Road Safety Audit Response Report

Client	Avant Homes
Project	Thurnscoe Bridge Lane, Thurnscoe
TPS Reference	P2423
Date Prepared	10.07.25
Prepared By	JT
Checked By	JA

Road Safety Audit Stage 1

Thurnscoe Bridge Lane, Thurnscoe, Barnsley – Road Safety Audit Stage 1

Revised Access Arrangements

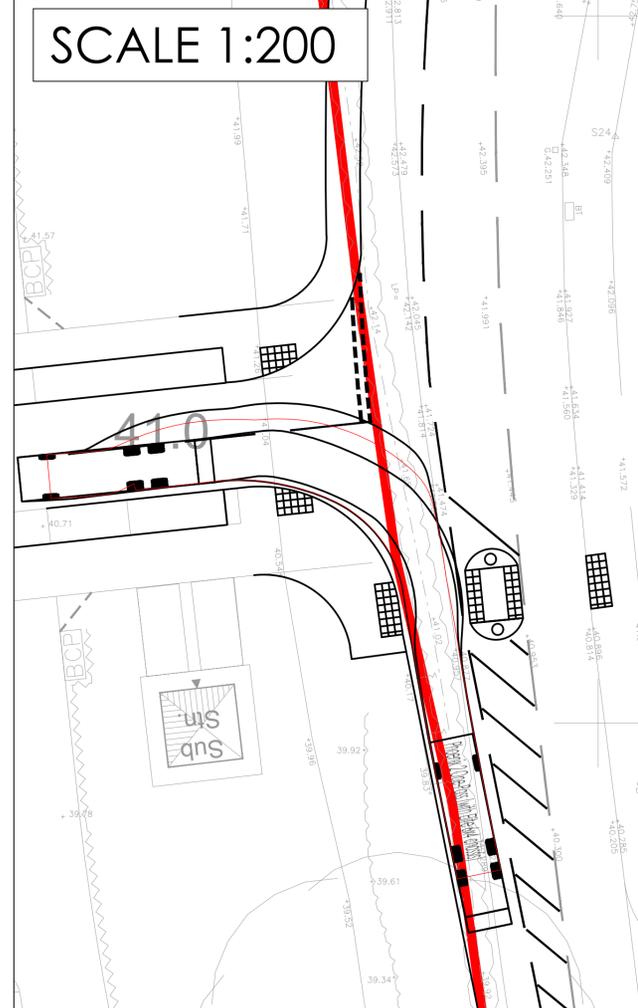
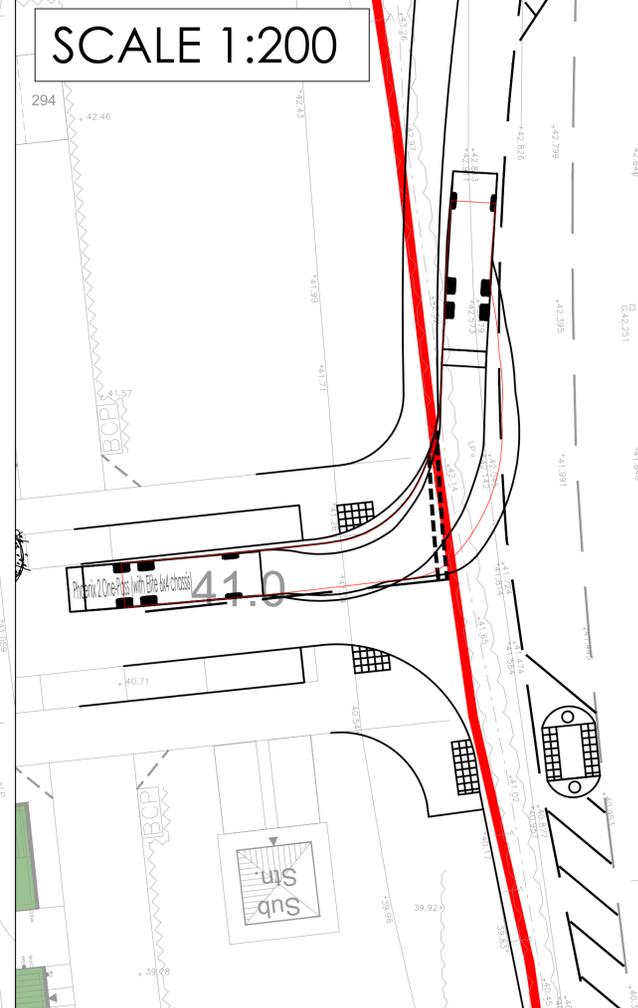
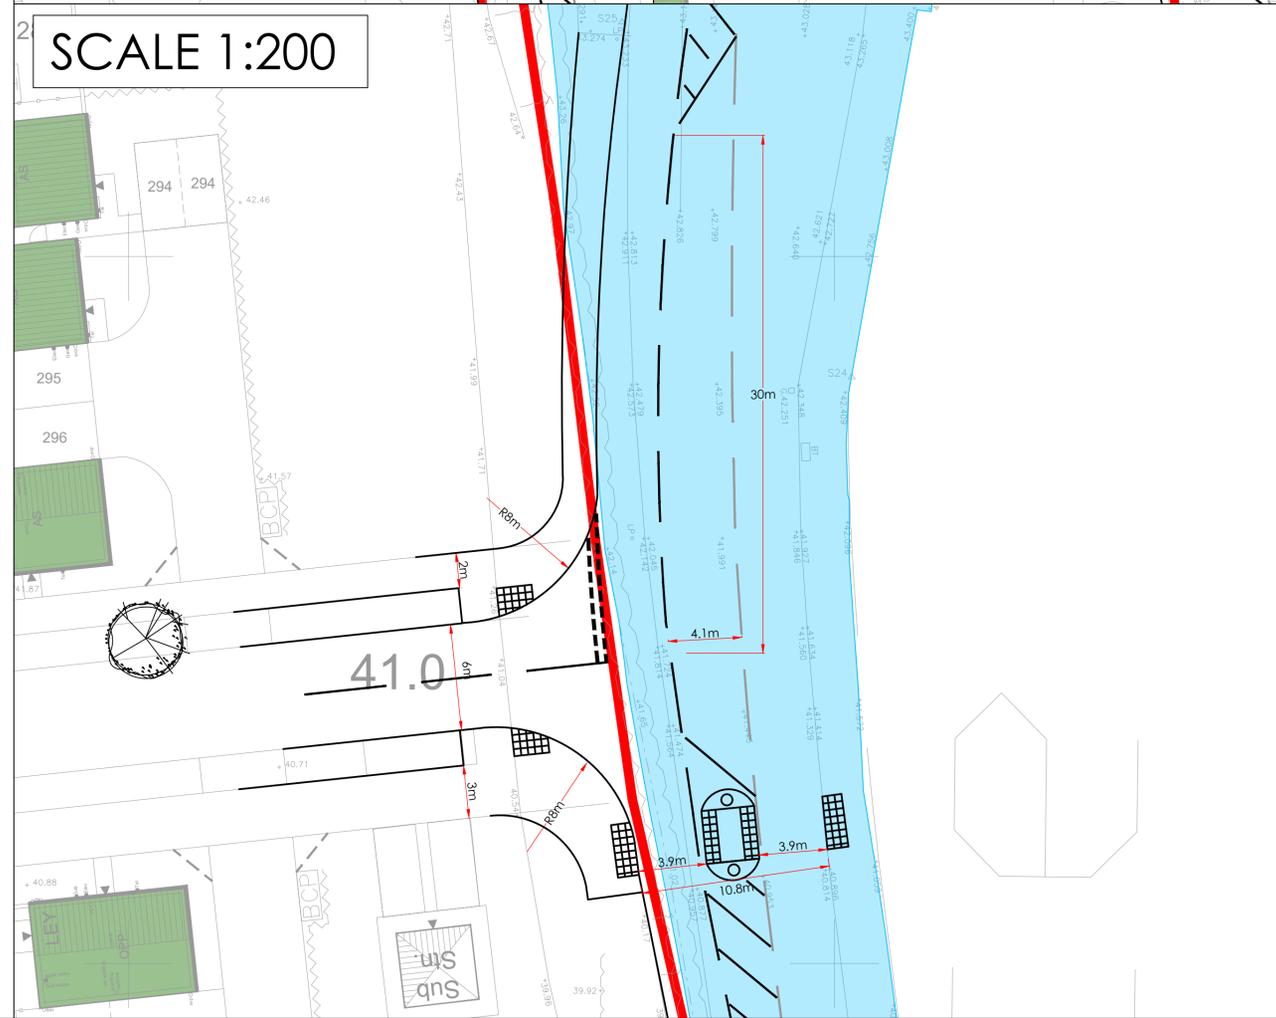
Date	Rev	Description	Drawn	Chkd
10.07.25	E	Access amended following undertaking of Stage 1 RSA	JT	JA
21.01.25	D	Access amended in line with highways consultation response	JT	JT
30.10.24	C	Minor alterations to tie in with development	JT	JT
29.10.24	B	Pedestrian refuge island widened to 3m	JT	GB
08.04.24	A	Access widened to 6m instead of 5.5m	JT	GB
